Walk Ride Bath - Bath Walking Wheeling Cycling Links Response

Introduction

| A36 Beckford Road crossing improvements..... | 25 |

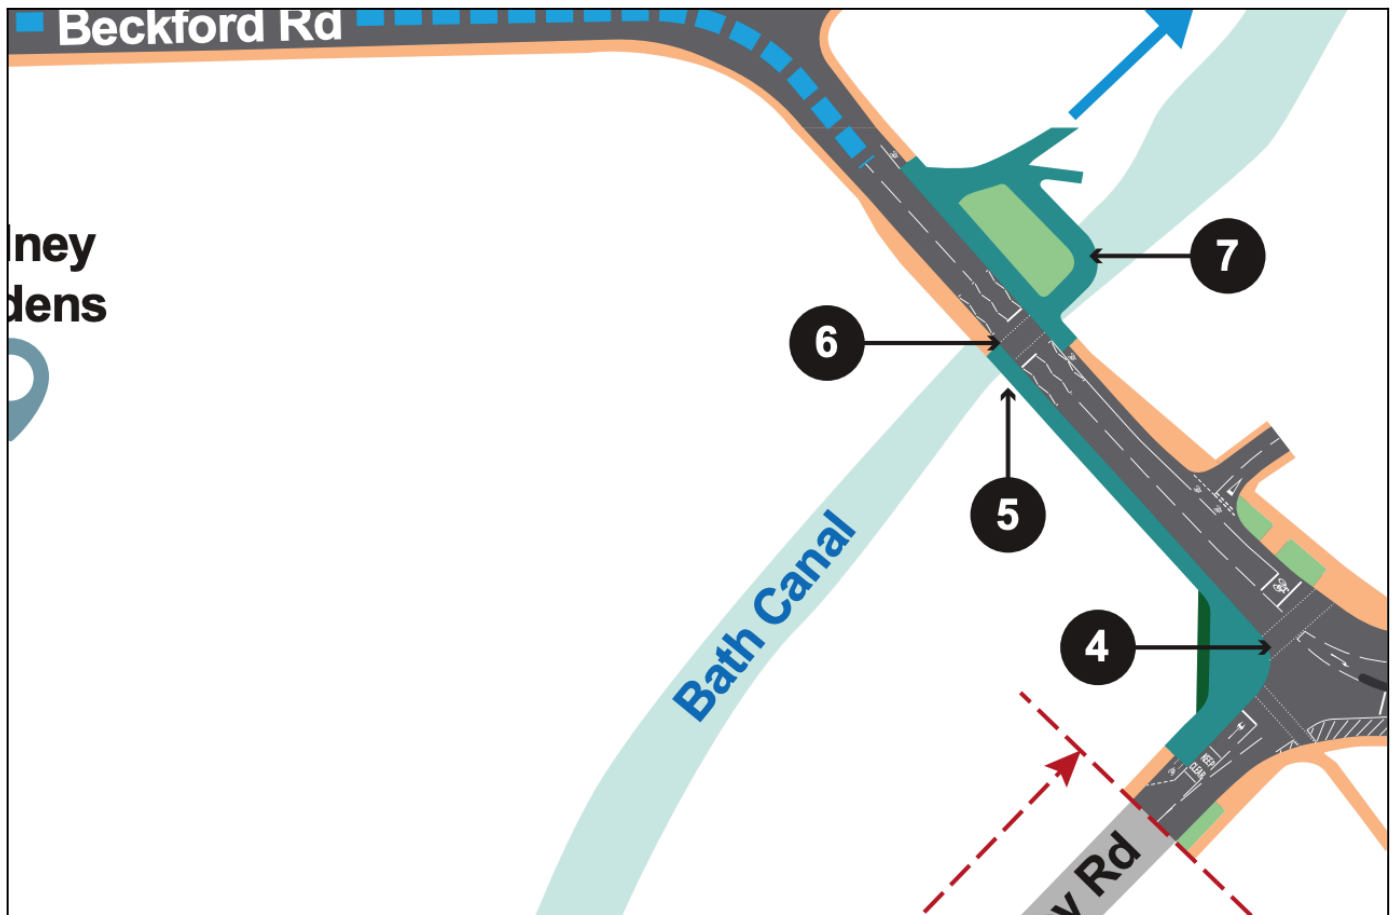
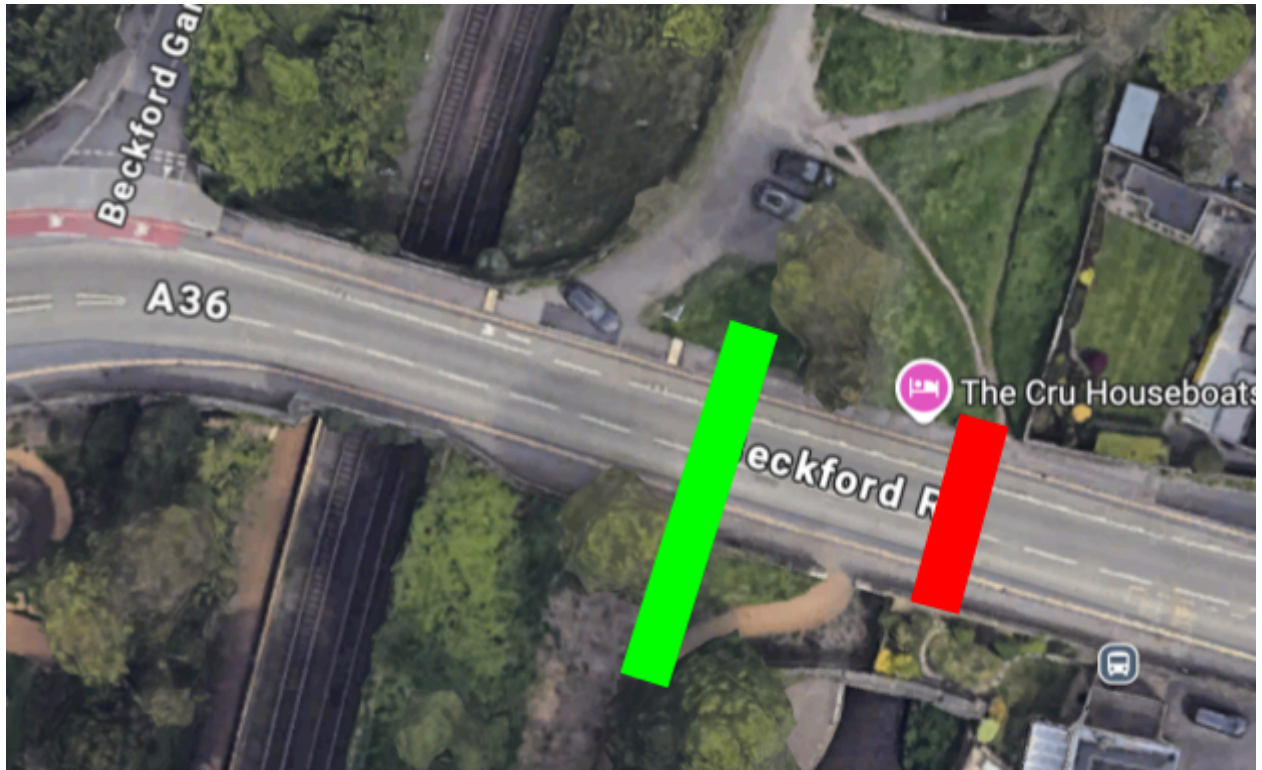
The proposed toucan crossing from the canal path to Sydney Gardens (and vice versa) would require people to wheel/cycle uphill, cross, then move downhill. Therefore:

- Align the crossing point to best satisfy the desire line (green), removing the awkward turns and elevation changes at the proposed crossing point (red) between the towpath and Sydney Gardens:

- Provide an all-weather surface within Sydney Gardens to meet the needs of all abilities, particularly wheelchair users.
- Ensure the new shared paths connecting the crossing to the towpath and the footway to Bathwick St Mary Primary School have wheelchair friendly maximum 1:20 elevation changes.
- Consider upgrading the Primary School access footway to a shared path.

Three Sides of Queen Square Mainly Traffic Free

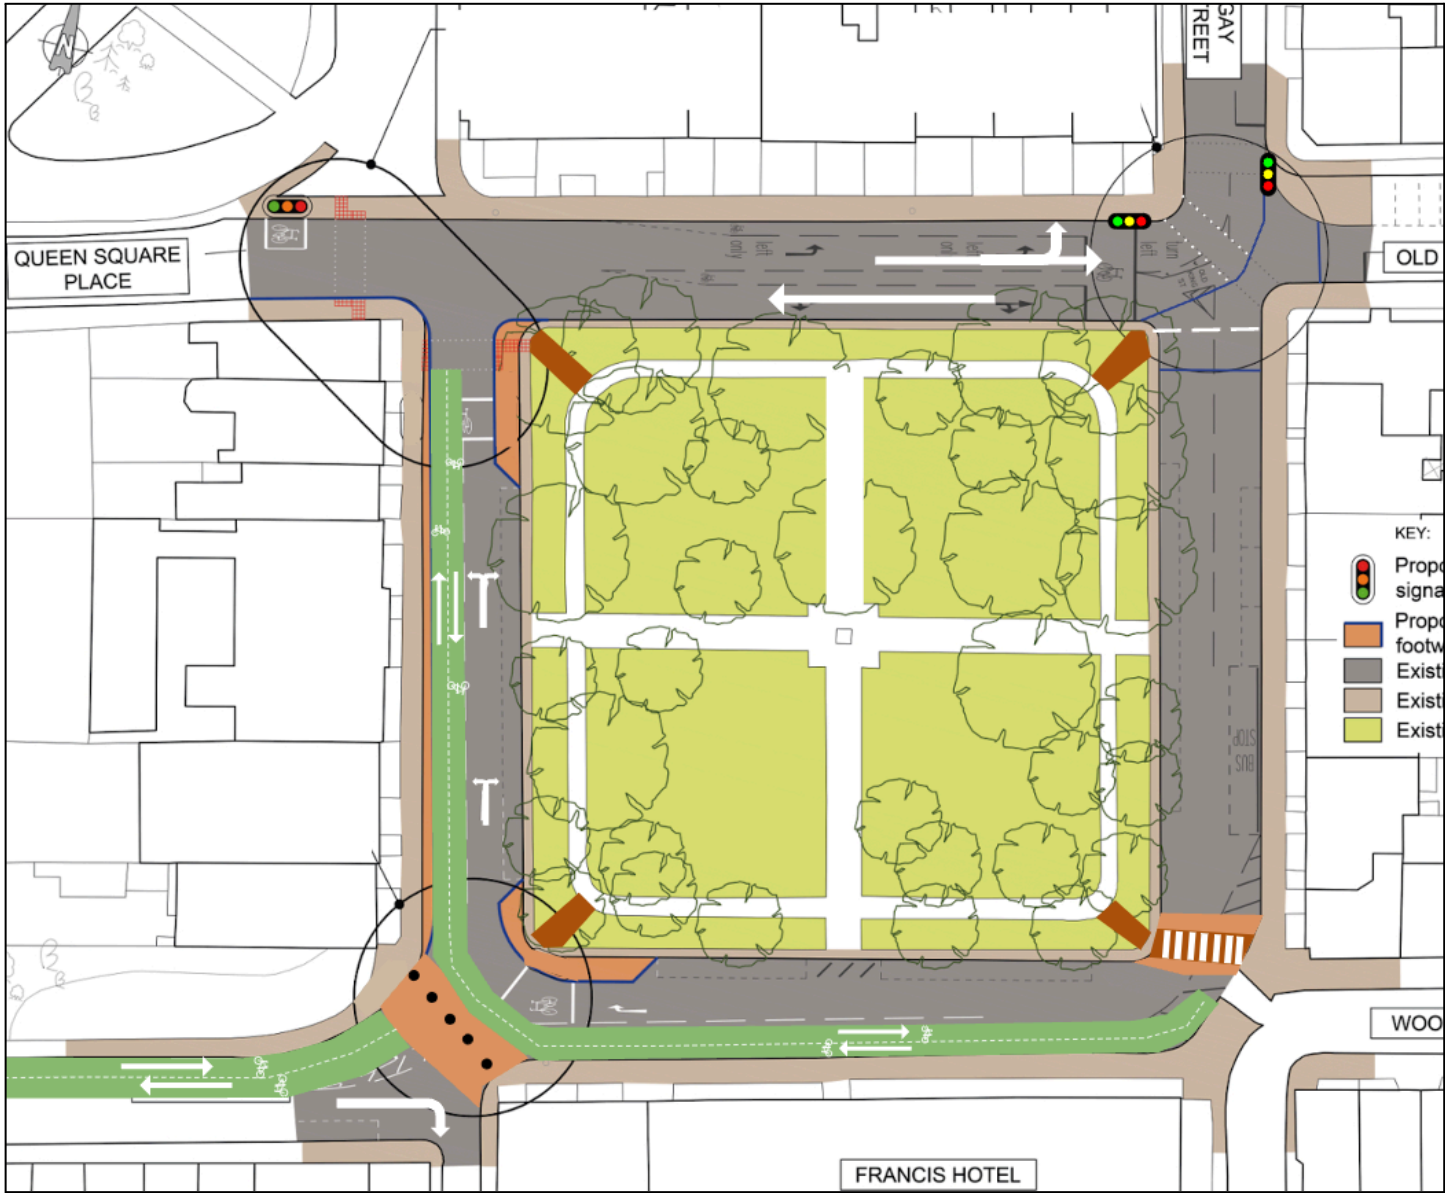
The proposed design does not provide a safe link from the south west corner of Queen Square to the Bath City Centre Charles Street cycle track via Chapel Row.

Make the east, south and west sides of Queen Square access only for motorised traffic. The north side would become two-way to all traffic accessing the north side of the city centre from the Upper Bristol Road, and Charlotte Street car-park which would be unaffected.

The two-way segregated cycle track on the west side should be implemented as proposed. However, it should be recognised that the desired line for most cyclists is for access to the northern part of the city centre. Therefore, add a two-way segregated cycle track on the south side of the square facilitating access to Milsom Street via Wood Street.

The southwest exit from Queen Square at Chapel Row should be closed to motorised traffic. A new two-way segregated cycle track should be implemented joining the proposed Charles Street cycle contraflow to the new Queen Square south side cycle contraflow. This would create joined-up cycle routes to the northern end of the city centre from Oldfield Park via North Quay, and the eastern end of the Strategic Transport Route where it emerges at Green Park.
